Re: DA 164-2019 Solar farm and associated infrastructure at 347 Dangarsleigh Road Armidale

Attachment 1 - Drawing Pack

PETERSONS SOLAR FARM

**Request for further information - DA-164-2019 Proposed 5MW Solar Farm and Associated Infrastructure,
347 Dangarsleigh Road, Armidale NSW**

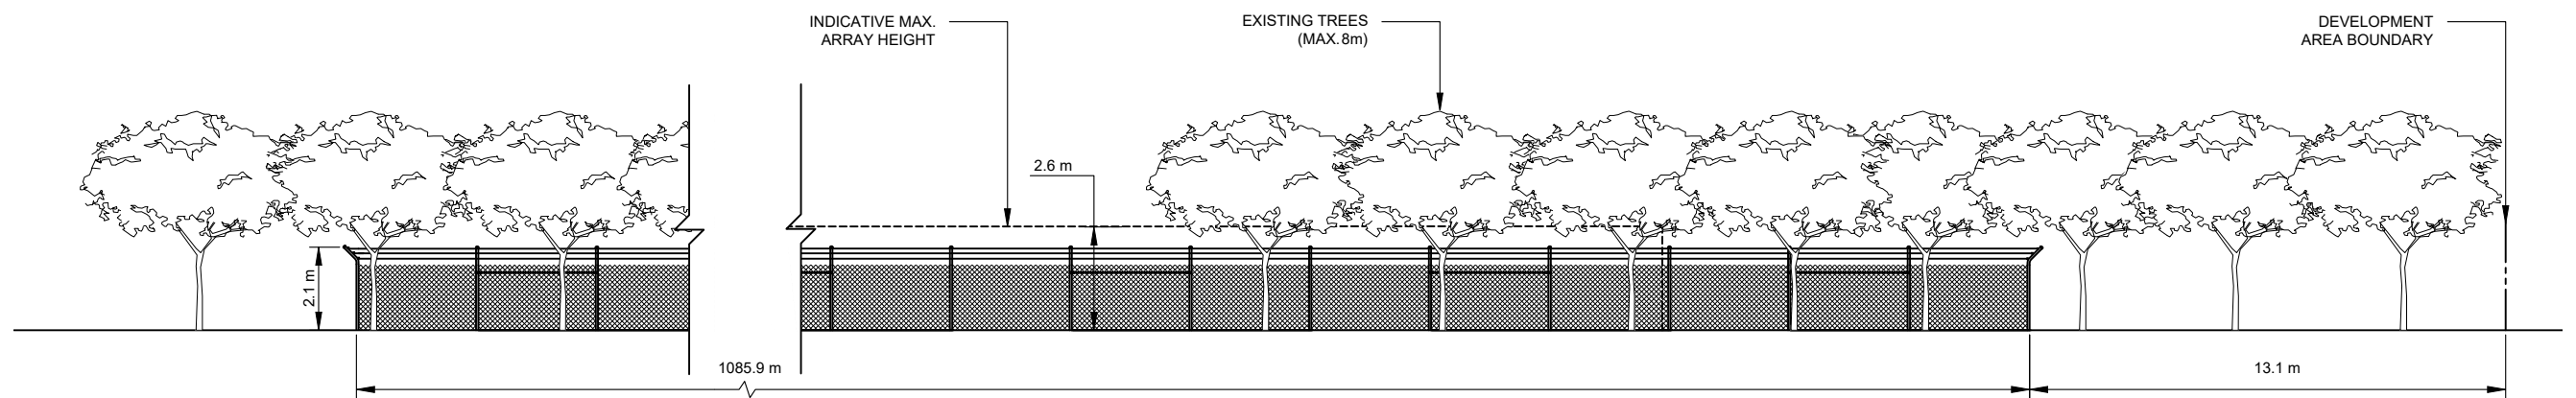
- *Proposed development on page 8 of SEE, states that the maximum height of the arrays will be 2.5m, while plans indicate that the maximum height of the arrays will be 2.617m. Could you please clarify for consistency?*

ITP confirms that the maximum height of the arrays will be 2.617m. This is consistent with the Statement of Environmental Effects which states that the peak of the modules will reach an *approximate* height of 2.5m when the array is fully tilted to 60 degrees from horizontal. Please refer to Drawing ARM1B-C-130 in the Drawing Pack attached to this submission in Attachment 1.

1 PLAN VIEW
SCALE: 1:50

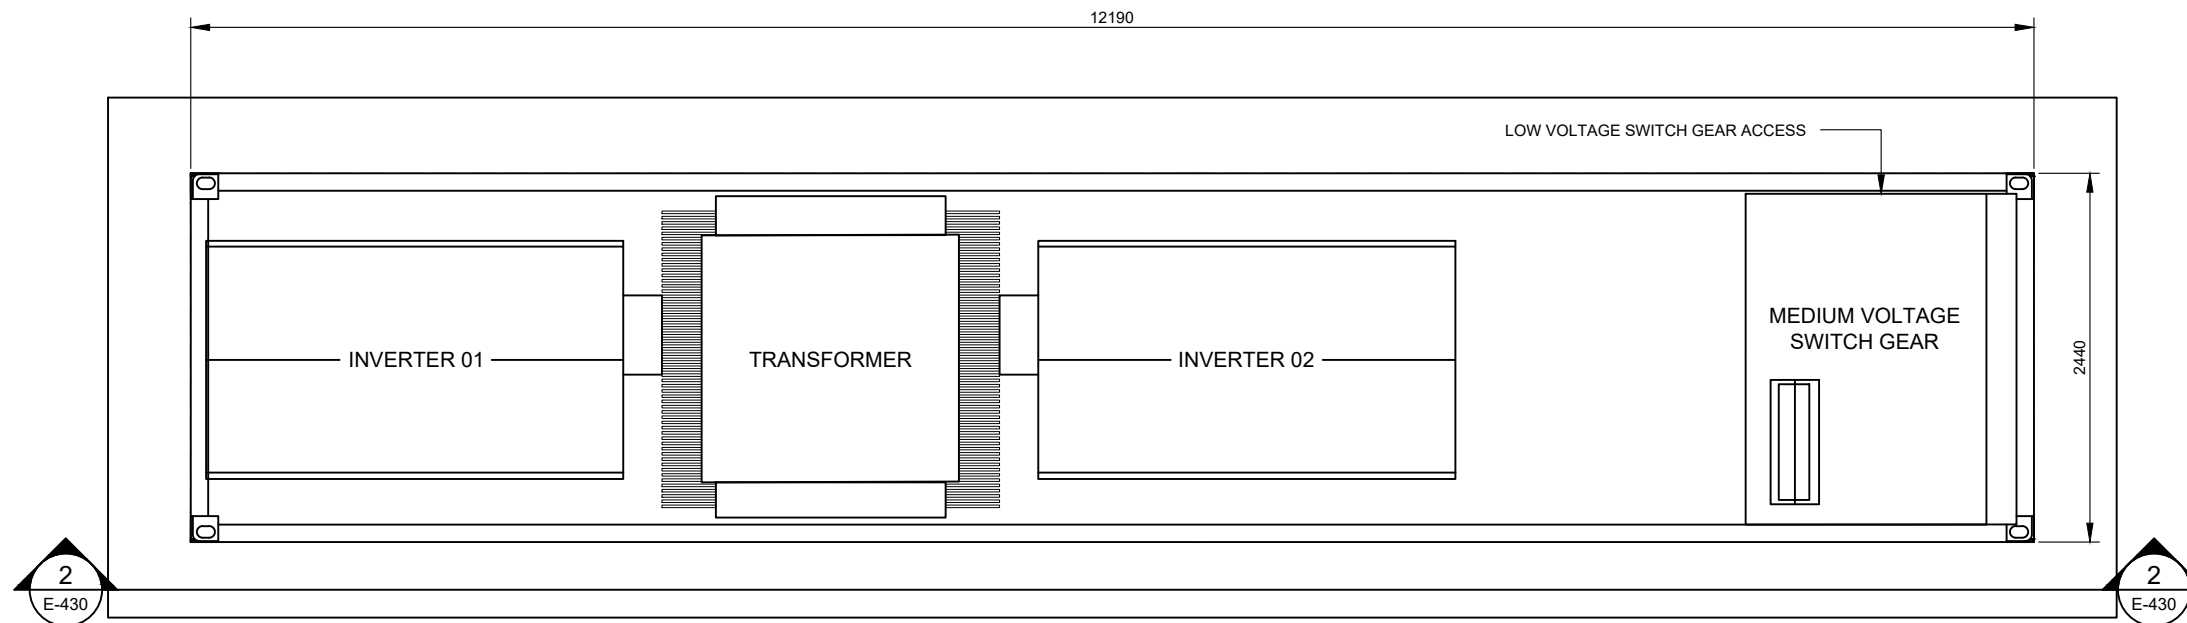
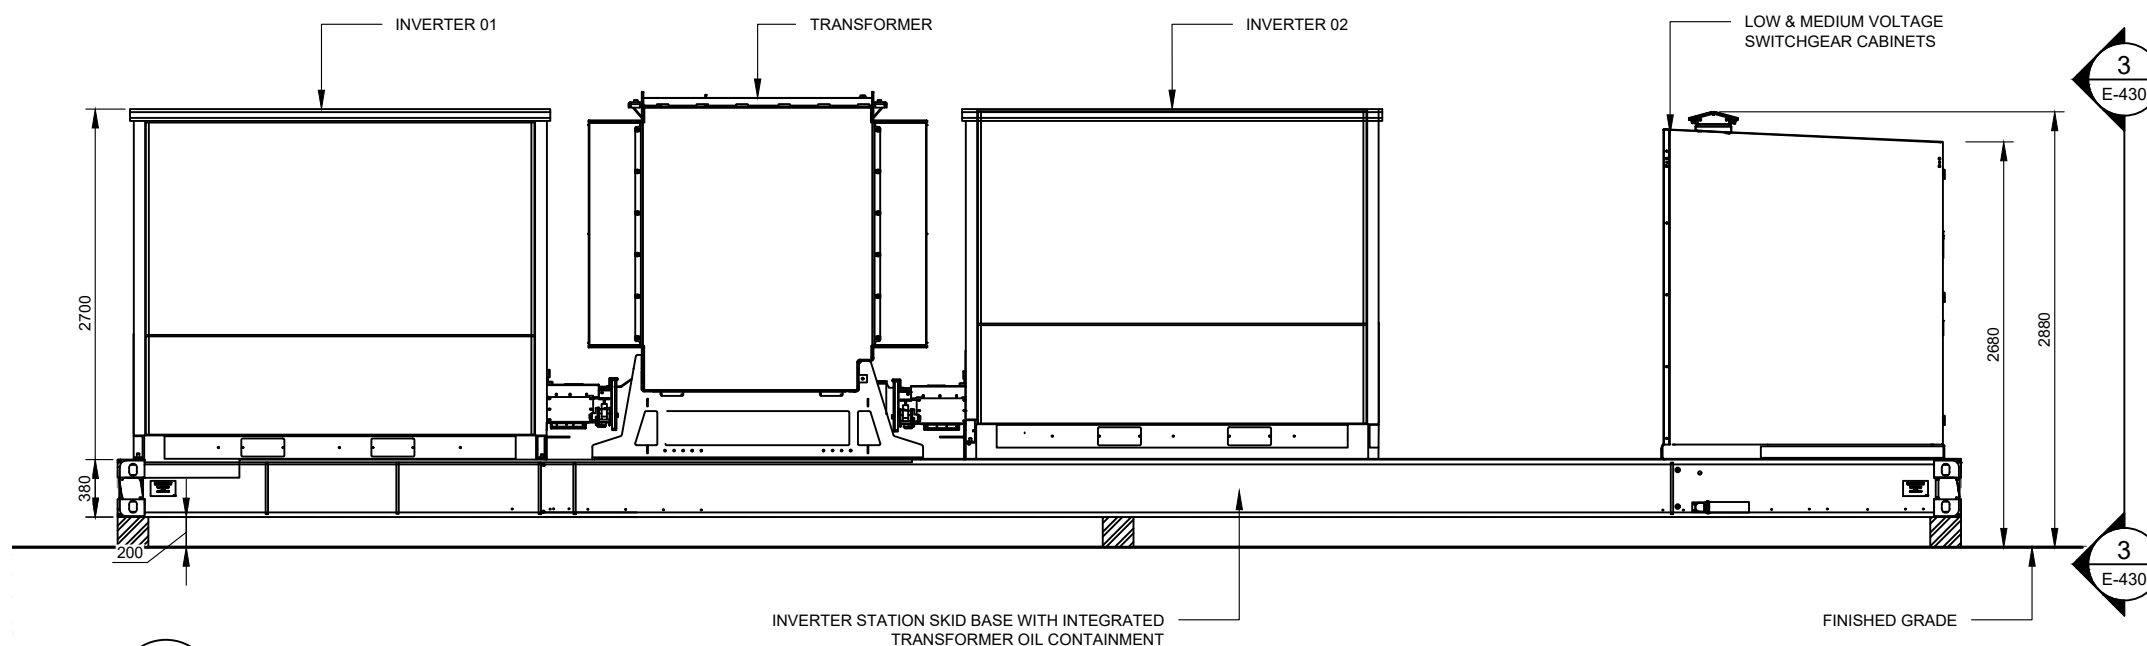
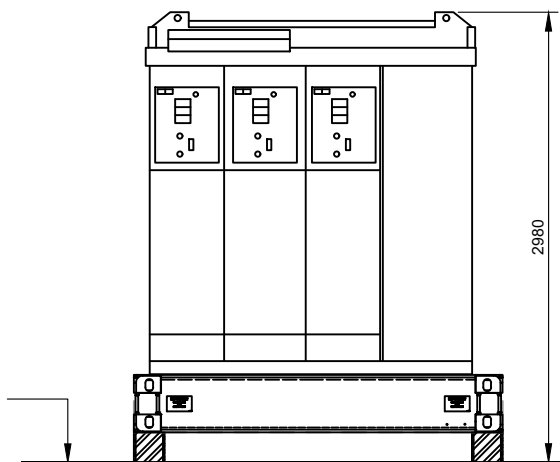
- *Page 8 of SEE states that each inverter will be mounted on a 6m long skid but submitted plan shows both inverters and transformer mounted on a 12.19m long skid. Please clarify for consistency?*

ITP confirms that the maximum skid length will be 12.19m for the two inverters and the transformer. ITP had considered locating the inverters separately on 6m skids each, however we have now confirmed the single-skid design. Please refer to Drawing ARM1B-C-430 attached to this submission in Attachment 1.

Figure 1: Extract from the NSW Topographic Map showing the location of watercourses on Palmerston

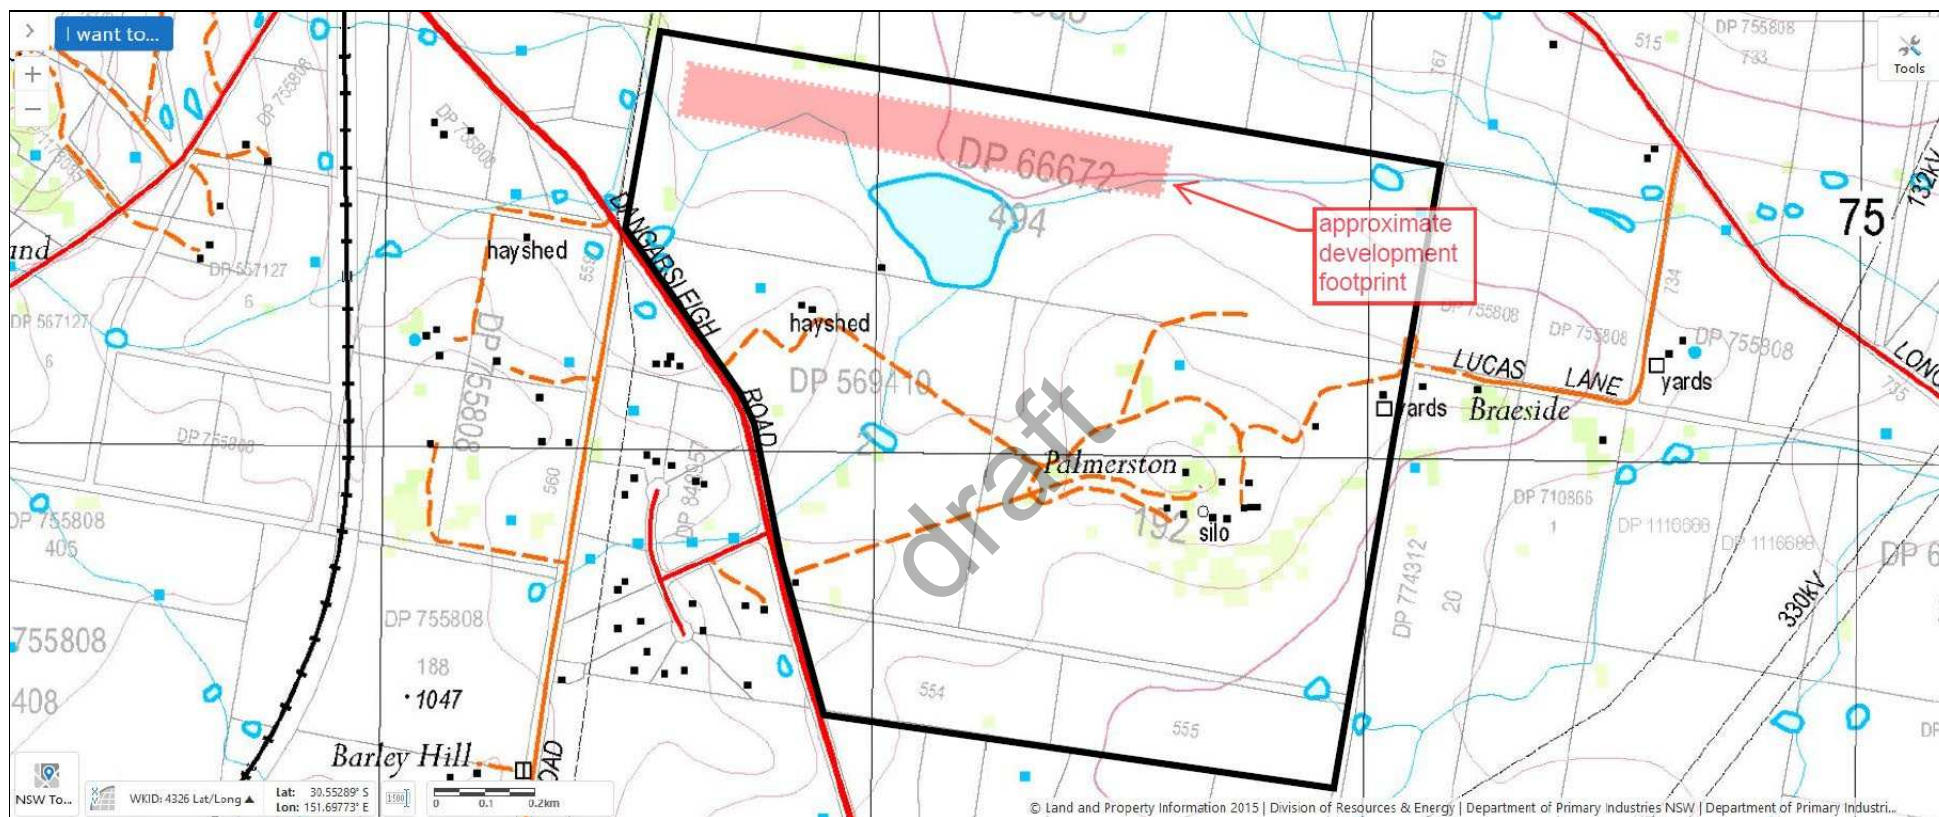
- *Are any separate approvals from State Agencies, such as Controlled Activity Approval, being separately sourced?*

There are three watercourses that traverse the development site shown as blue lines on the attached extract from the topographic map (Figure 1) that has been sourced from SEED. Access to the proposed solar farm will cross the watercourse that enters Lot 2 just north of the entrance driveway, flows into a small dam thence a larger dam in Lot 494. Access and the placement of the array will also be within 100 metres of two streams that enter Lot 494, then converge before entering the large dam.

Attachment 4 – Swept Path Diagram

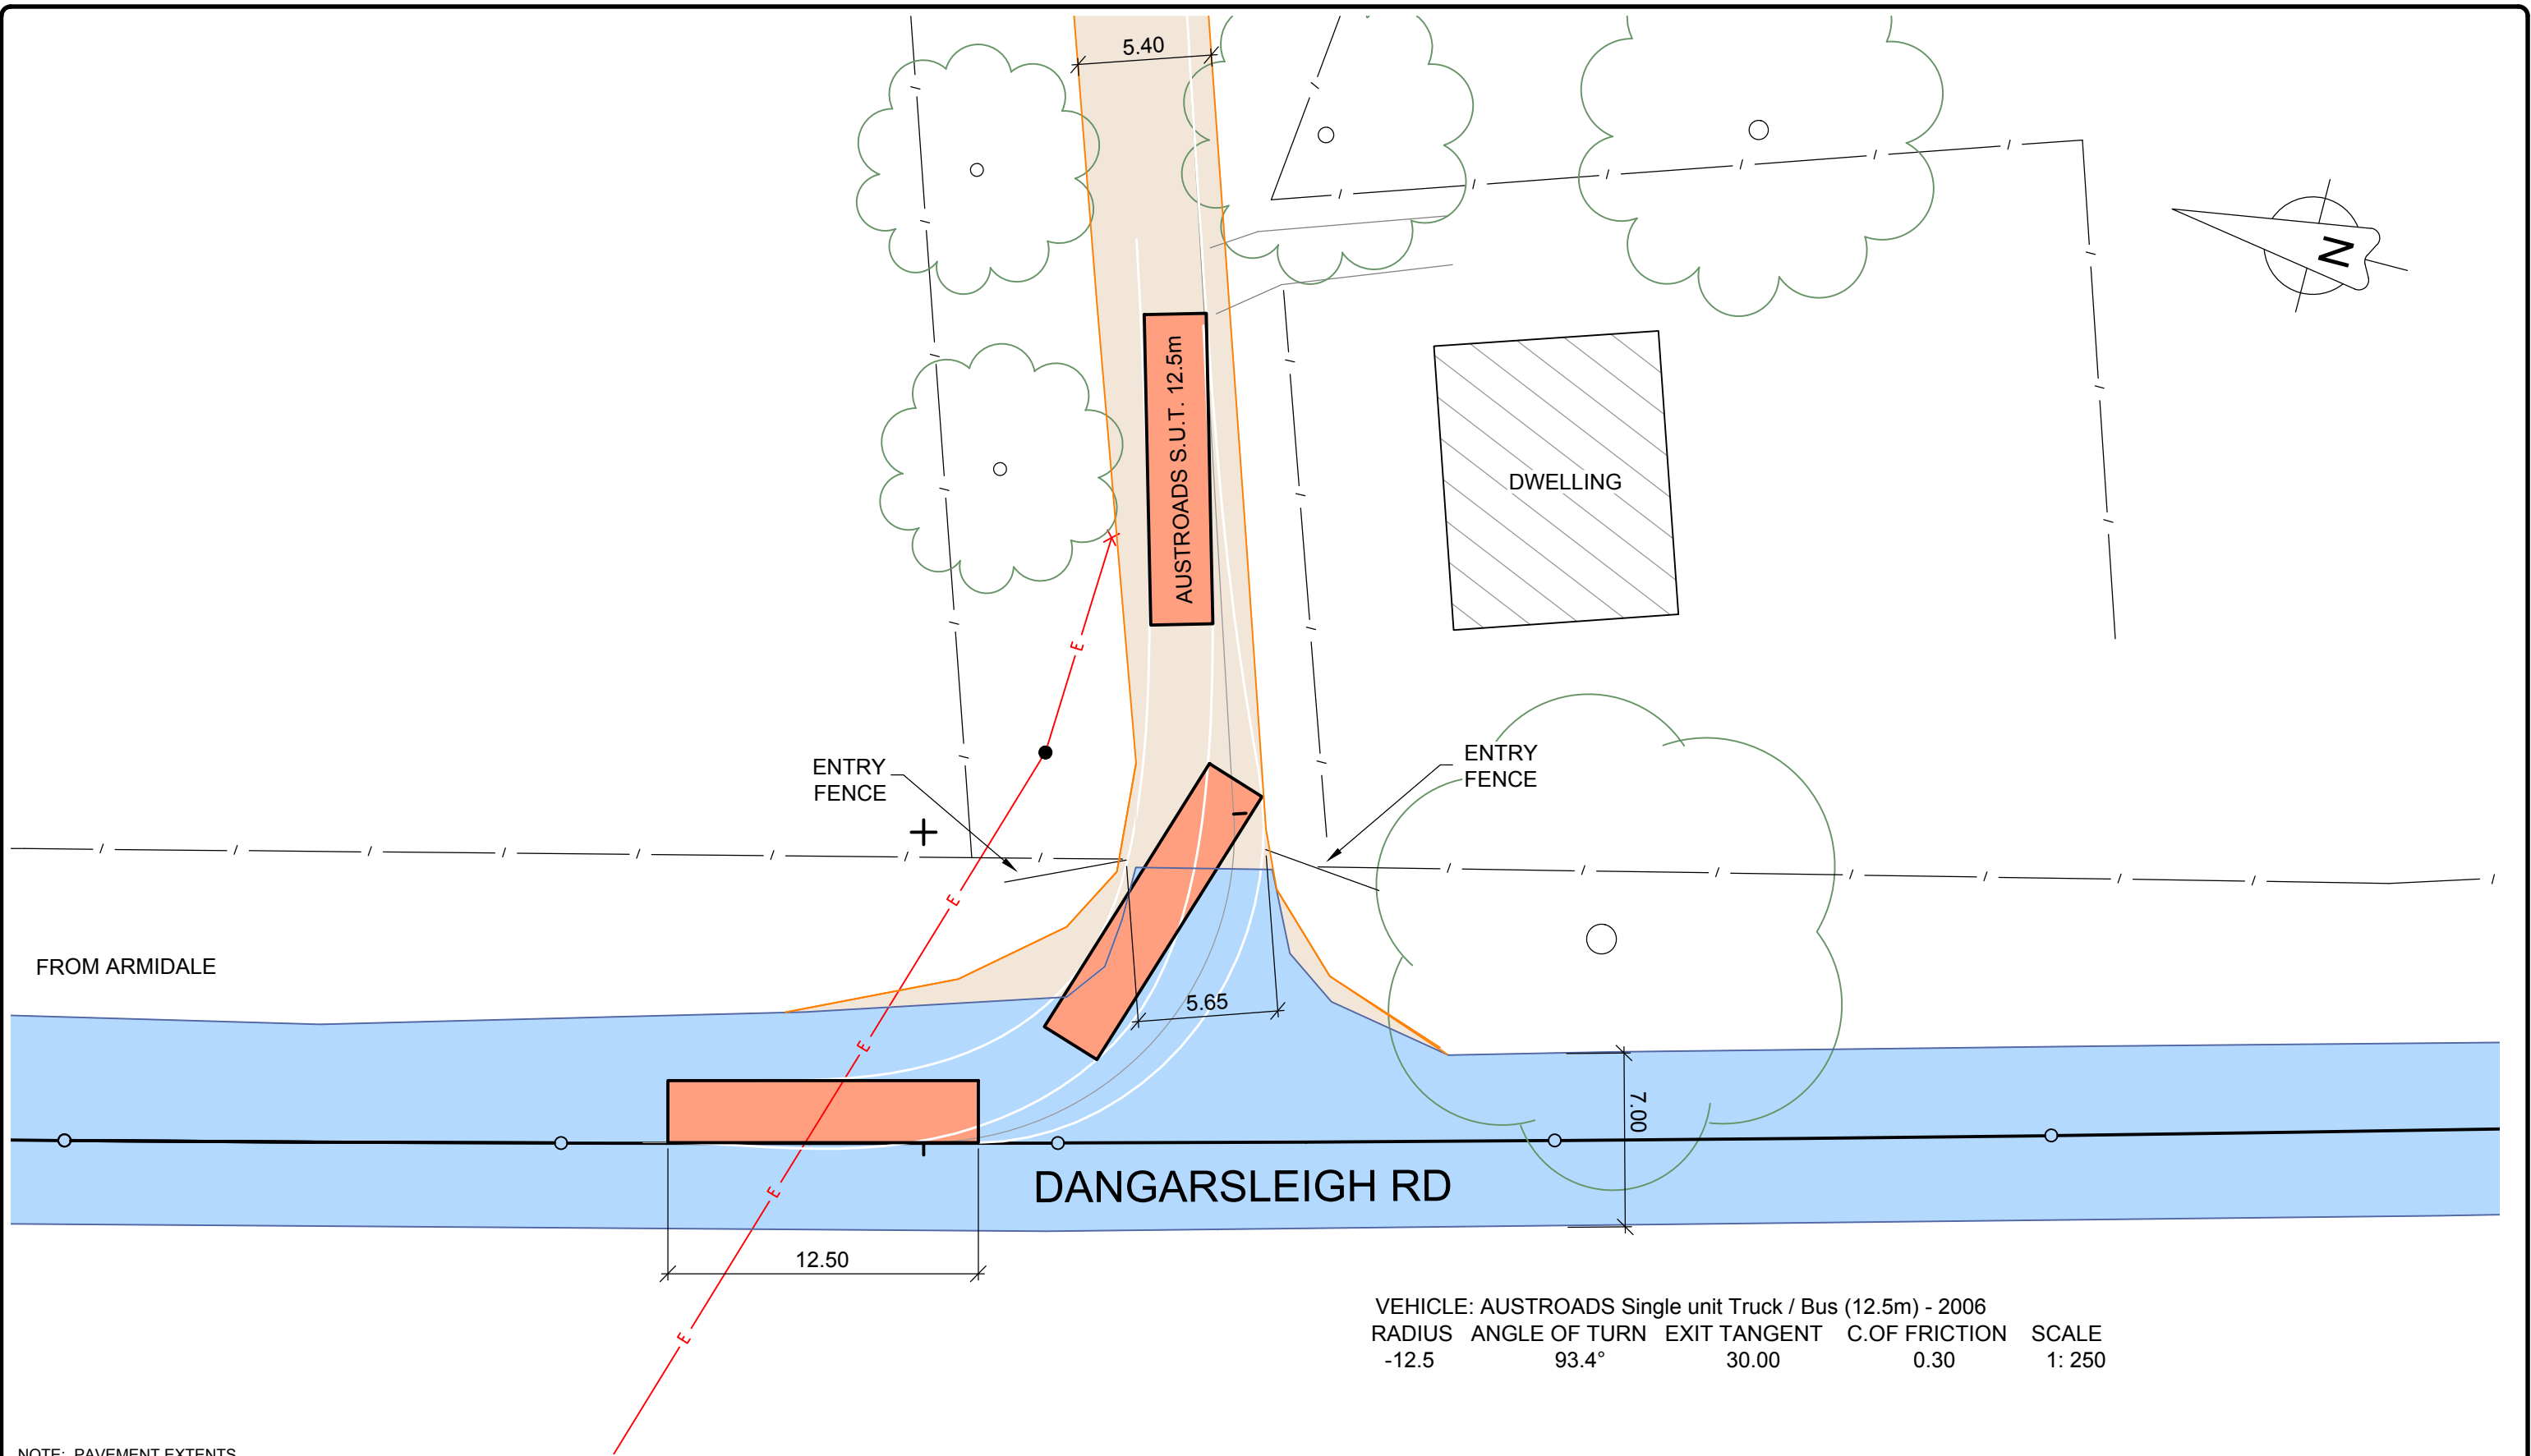
- *Please provide a swept path analysis for the largest type of vehicle proposed to be used to access the site demonstrating that they can negotiate the ingress/egress safely without any upgrades.*

ITP has commissioned our traffic consultants, New England Surveying & Engineering, to provide a swept path diagram for a single unit truck being 12.5m in length. Please refer to the diagram attached to this submission at Attachment 4.
